National Beyond visual line of sight Experimentation Corridor
Airspace Change Proposal

Targeted Engagement report

12 May 2021

Engagement report – Cranfield NBEC ACP

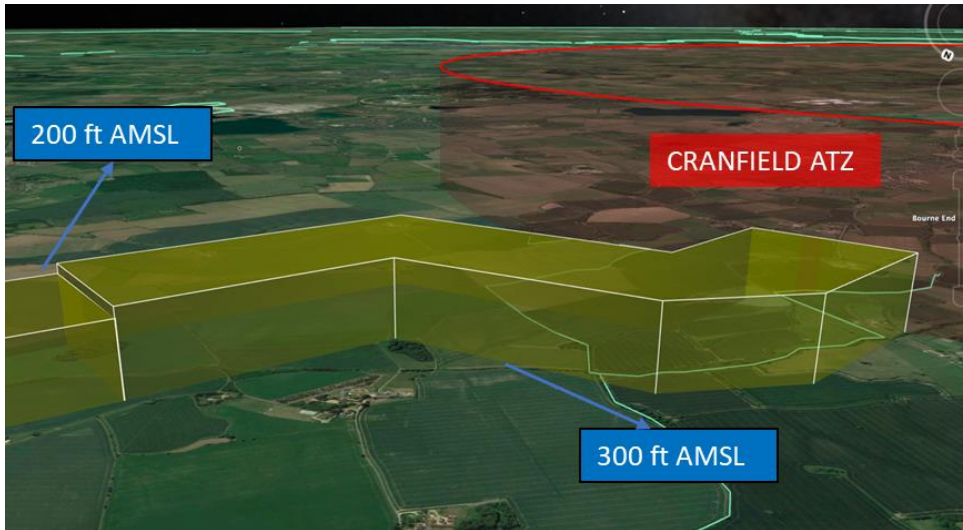
A further review of the route considering avoidance of villages was also conducted.

- The airspace will be activated by NOTAM.
- NOTAMs will include contact details including Cranfield ATCs telephone number and frequency.
- NOTAMs will be published at least 24 hours in advance.
- Cranfield ATC will provide a DAIS as described in Appendix E.
- UAV flight path routing has been adjusted to minimise residential overflight.
